Access Compliance Report

Public Rights-of-Way

(Curb Ramps)

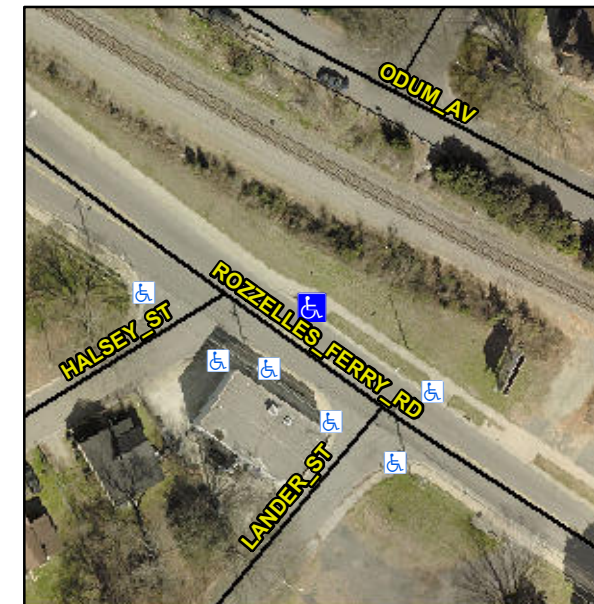
Intersection ID: 8706	Main Street: HALSEY_ST	Cross Street: ROZZELLES_FERRY_RD	Location: NE
ADA ID: D2F4EB28C17C	Ramp Type: Perp	Initial Pass/Fail: Fail	Overall Compliance: No
Severity Score: 8.75			
Codes/Mitigation Info/Possible Solution		Field Measurements/Component Compliance

Not Found, R304.5.1

Remove & Replace Entire Ramp.
